Sundry Notices and Reports on Wells

San Juan 27-4 U #120

**Attachment to Notice of
Intention to Workover**

**Re: Sidetrack
Well: 120 San Juan 27-4 Unit**

CURRENT WELLBORE SCHEMATIC

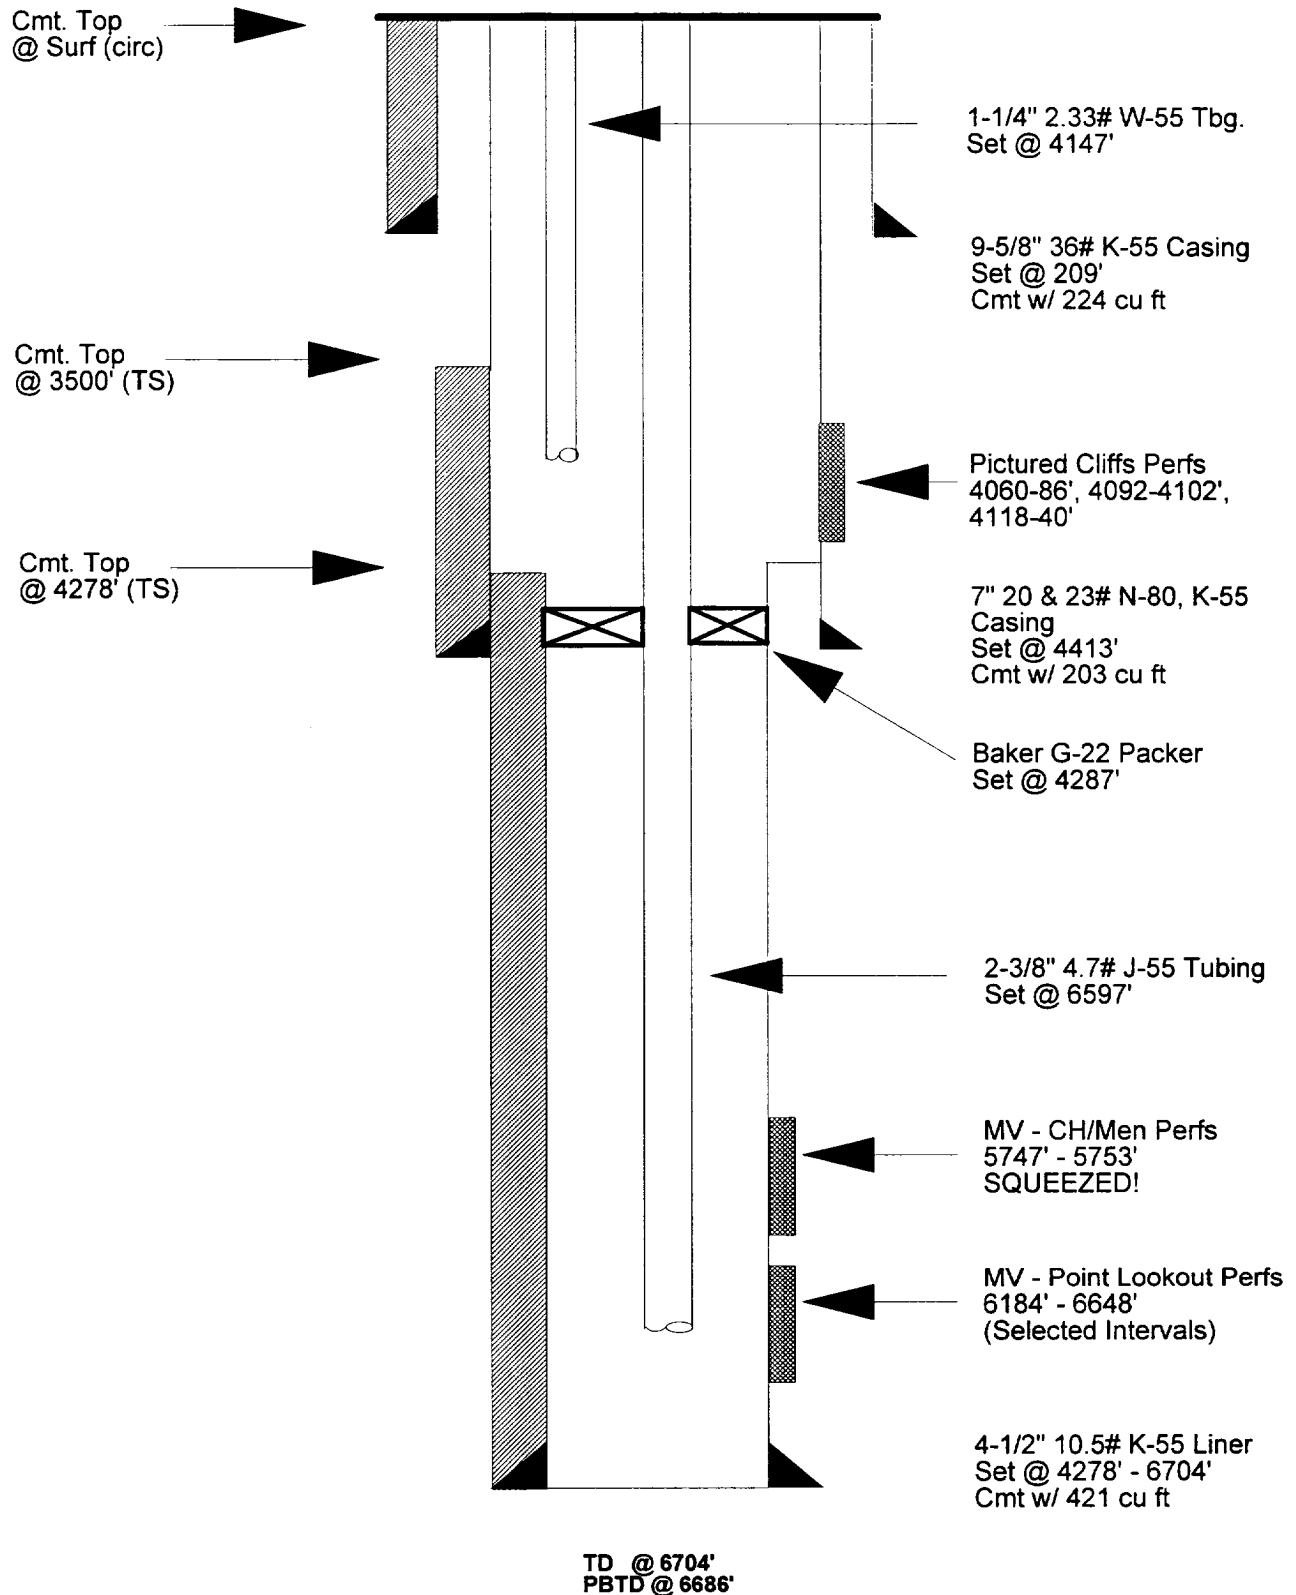
1. An additional cement plug is required from 4463' to 4228' inside the casing. (7" csg. set at 4413', TOL at 4278')
2. Recalculate the volume of cement to squeeze the Mesaverde (145sxs) and the Pictured Cliffs. (85 sxs.)
3. **Mike Flaniken** with the Farmington District Office is to be notified at least 24 hours before the workover operations commence (505) 599-8907.
